# **Botley West Solar Farm**

Applicant's Response to Rule 17 Letter (14th October 2025)

Document Ref: EN010147/APP/17.8

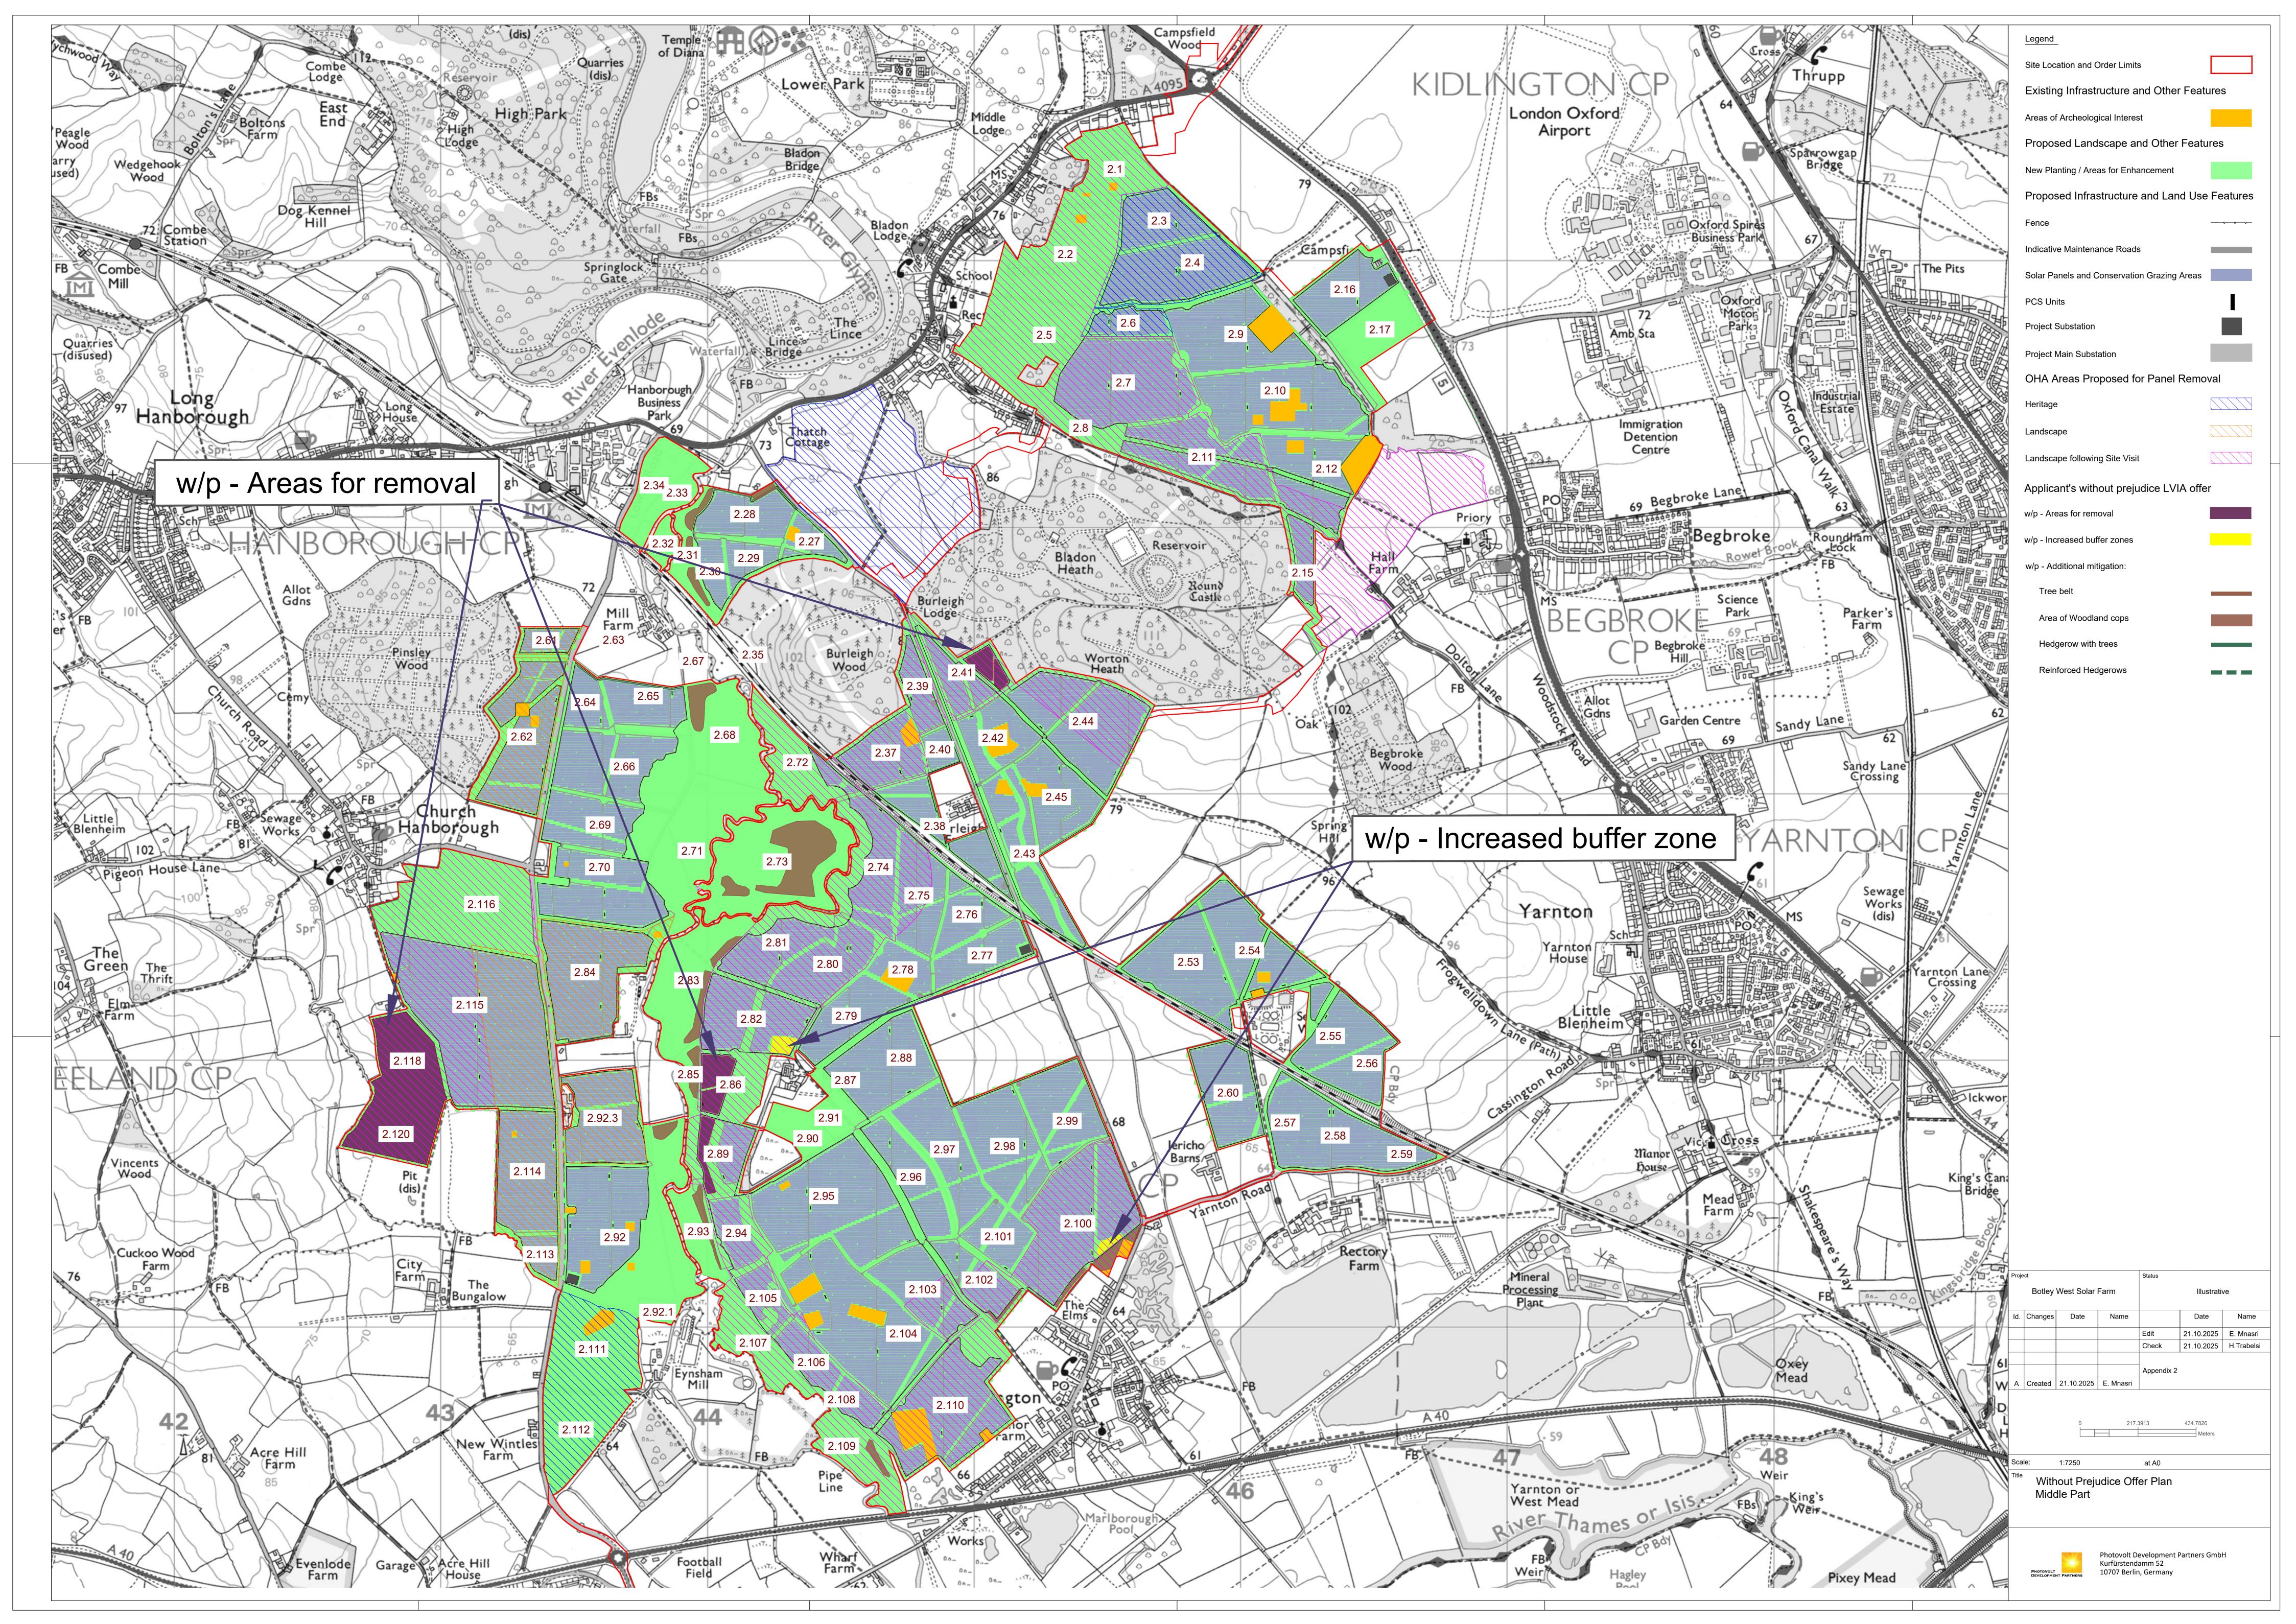
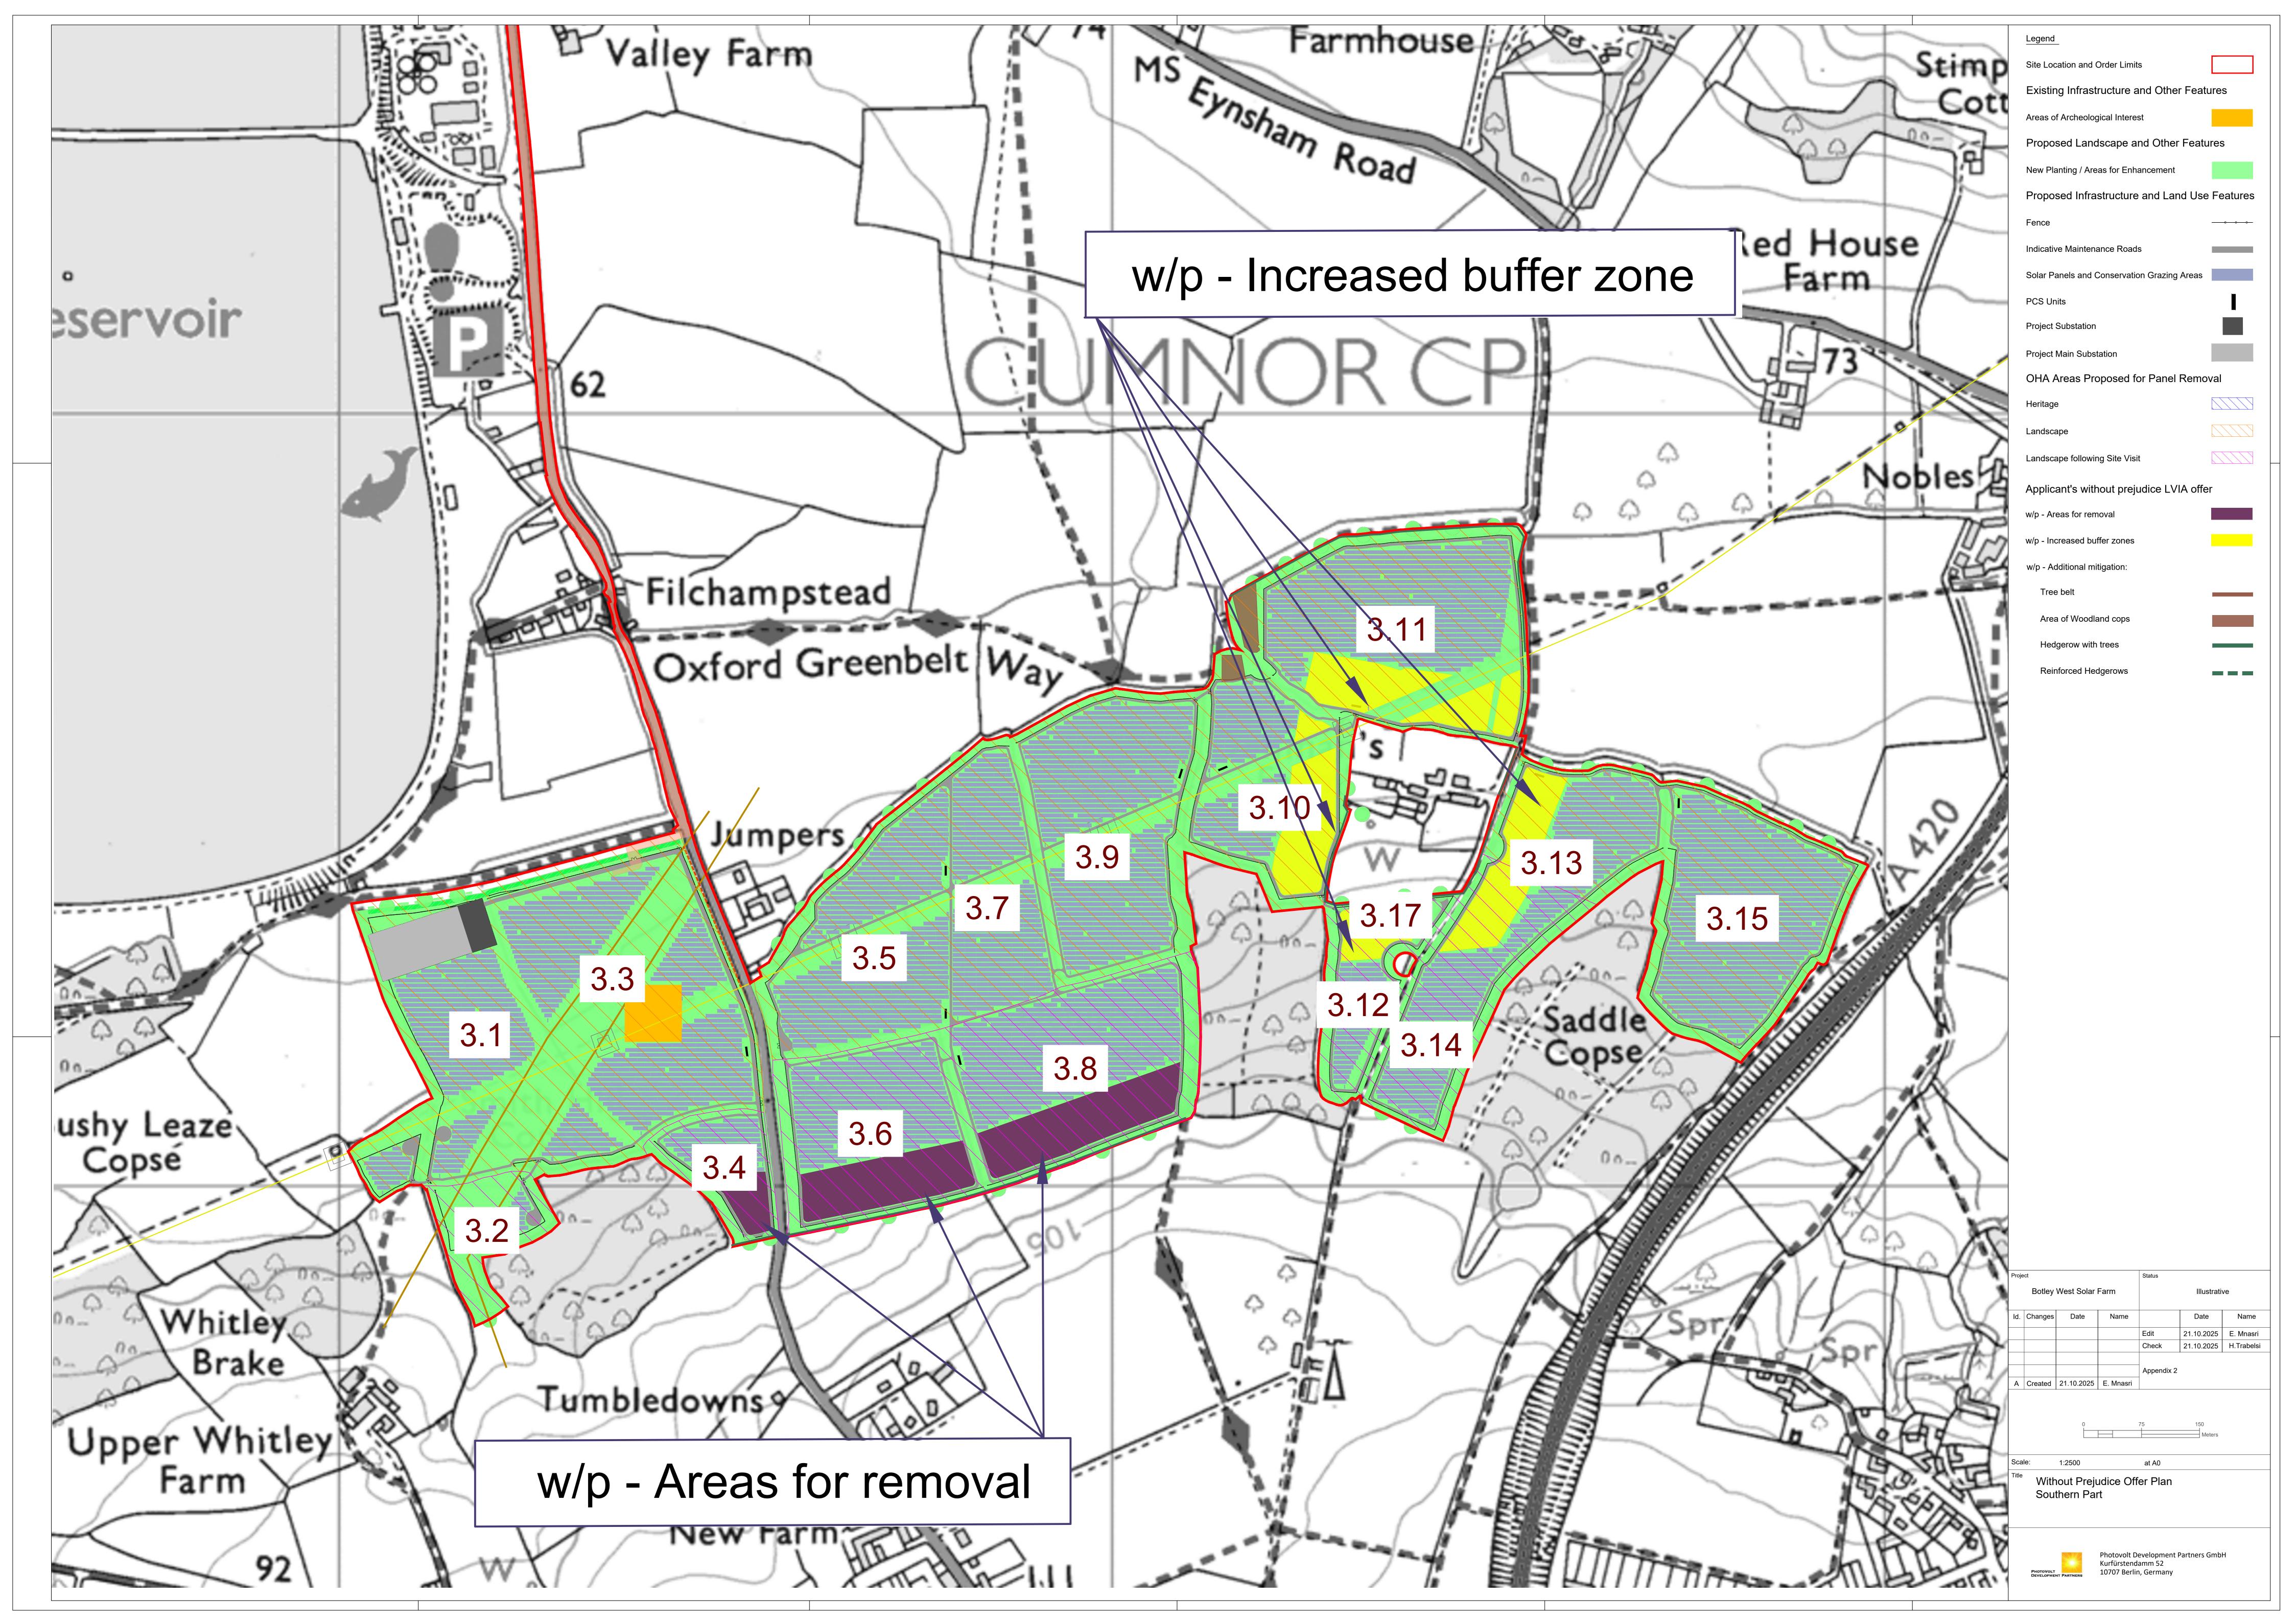
In regard to Paragraph 2.10.29, the Project design process did take into account the likelihood of areas of best and most versatile land at an early stage. The attached Figure 1 shows the location of the proposed development in relation to the Provisional ALC mapping and shows the location of the Project area in the context of the wider Oxfordshire County. It is clear from this overlay that the location of the areas of the Project falls almost wholly within Grade 3 with some potential Grade 4 land, which compares favourably with surrounding districts within the County of Oxfordshire, where there are significant areas of Grade 2 and also limited areas of Grade 1 land.

Figure 2 shows the distribution of ALC survey work that has been undertaken by DEFRA in Oxfordshire using the current Agricultural Land Classification guidelines. The tables below summarise the quality of the agricultural land identified within each district, based on these surveys and excludes areas of non-agricultural land identified within the survey sites:

Response to ExA's Points 9 and 10 – Part 3: Applicant's Without Prejudice LVIA Offer

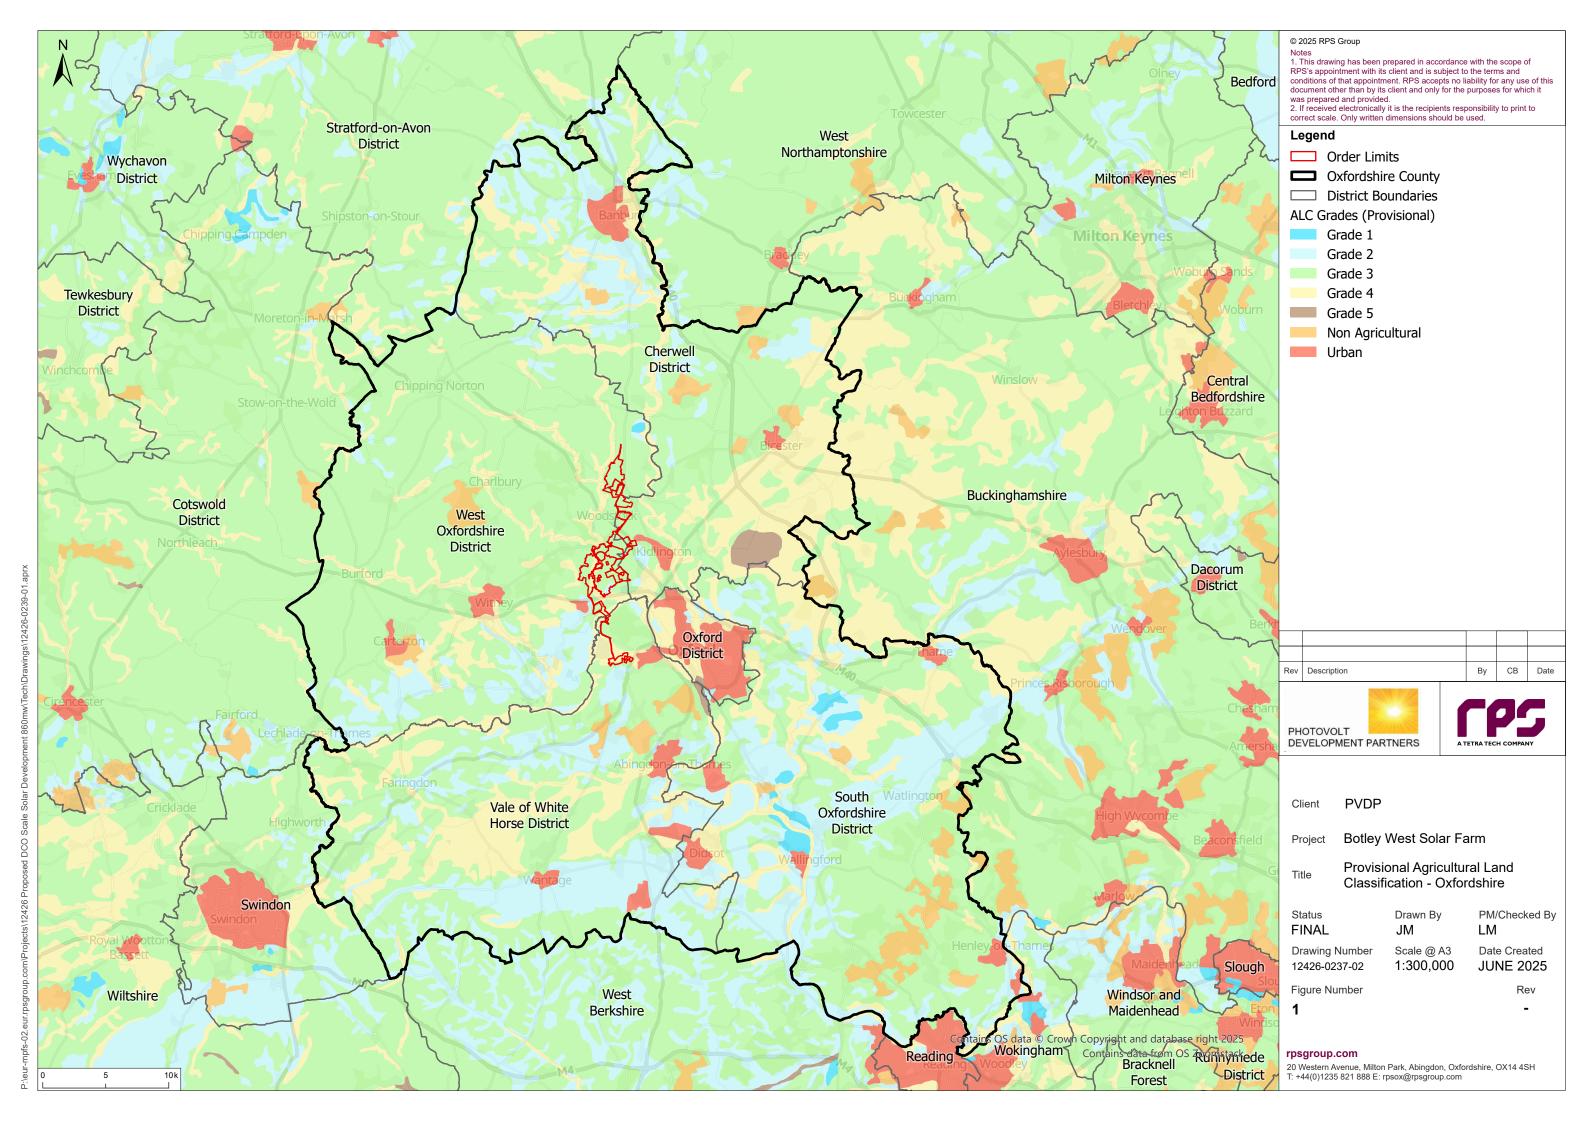
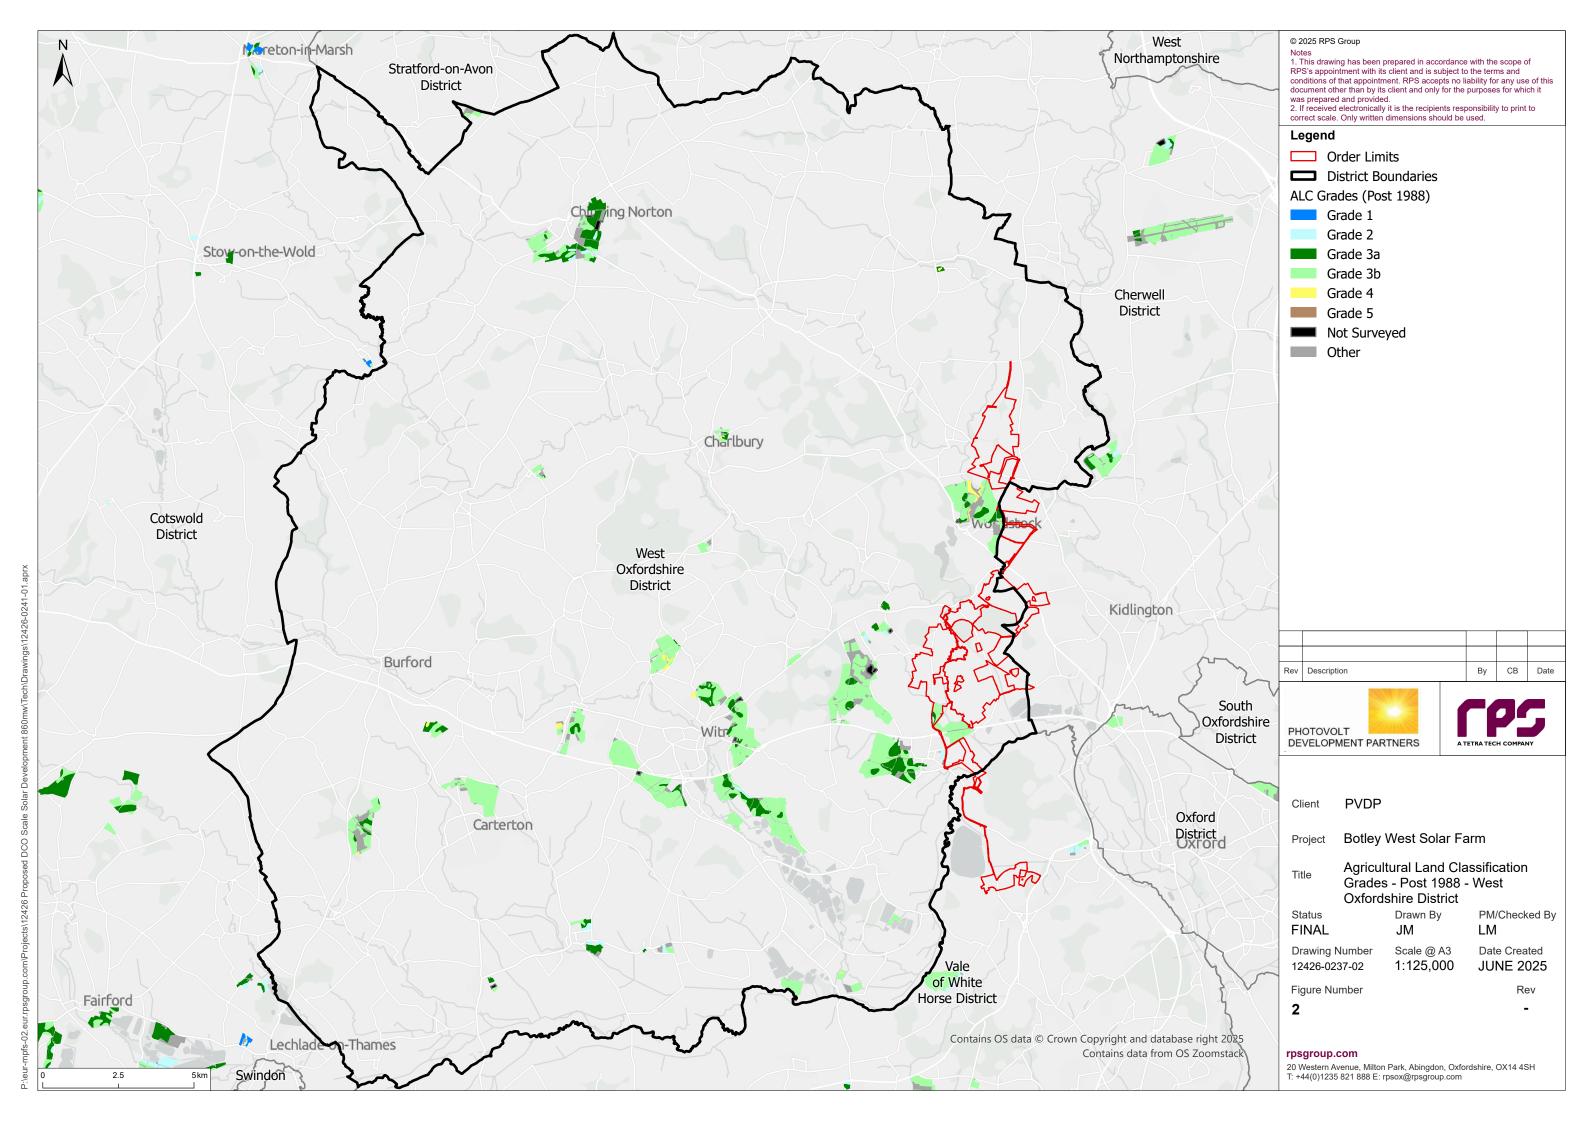
See the plan at Appendix 2 (part (a)) to this response for the plan showing the areas of removal and buffer zones that form the without prejudice offer. Part (b) of Appendix 2 explains the loss of function associated with each proposal.			
10	In EXQ2.9.5 we asked about residual effects. In your	The Applicant has approached this question in three parts:

w/p – areas for removal	Location	Loss in installation area	Capacity Loss
1,12	North	2,20 ha	3,67 MWp
1,13	North	2,25 ha	3,75 MWp
2,41	Middle	1,40 ha	2,33 MWp
2,86	Middle	2,01 ha	3,35 MWp
2,89	Middle	0,86 ha	1,43 MWp
2,118	Middle	5,95 ha	9,92 MWp
2,120	Middle	5,56 ha	9,27 MWp
3,4	South	0,40 ha	0,67 MWp
3,6	South	1,32 ha	2,20 MWp
3,8	South	1,53 ha	2,55 MWp
Total		23,48 ha	39,13 MWp

w/p - increased buffer zones	Location	Loss in installation area	Capacity Loss
Weaveley Farm	North	2,70 ha	4,50 MWp
Perwell Farm	Middle	0,84 ha	1,40 MWp
Increased buffer near Cassington	Middle	1,46 ha	2,43 MWp
Denmans Farm	South	4,20 ha	7,00 MWp
Total		9,20 ha	15,33 MWp
